SUBJECT: Forwards clarification of Section 4.1, "Structural Analysis of Spray Pond Piping Sys" in response to 851003 request. Clarification addresses weld corrosion evaluation & provides supporting calculations.

Subject: Palo Verde Nuclear Generating Station (PVNGS)
Units 1, 2, and 3
Docket Nos. STN-50-528 (License NPF-41)/529/530
Clarification of Structural Analysis for Spray Pond Piping
File: 85-056-026; G.1.01.10

STRUCTURAL ANALYSIS OF THE SPRAY POND PIPING SYSTEM

14" ϕ PIPE WITH
108- $\frac{1}{8}$ " HOLES
ABOUT
CIRCUMFERENCE

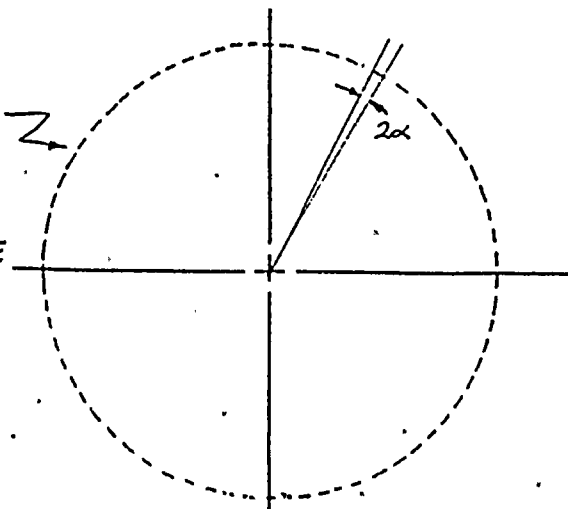
FOR THE MOST CRITICAL 14" ϕ PIPE, 108- $\frac{1}{8}$ " ϕ HOLES WILL RESULT IN A WELD REDUCTION OF APPROXIMATELY 30%, WHICH IS GREATER THAN THAT PREVIOUSLY CALCULATED. THE PIPE INTEGRITY WILL BE RECALCULATED (BASED ON MINIMUM WALL THICKNESS BUT EXCLUDING OTHER PREVIOUS CONSERVATIVE ASSUMPTIONS).

$$\sigma_{14\phi} = 0.93 + 37.4 = 38.3 \text{ ksi} < 39.3 (S_n + S_A) \therefore \text{O.K.}$$
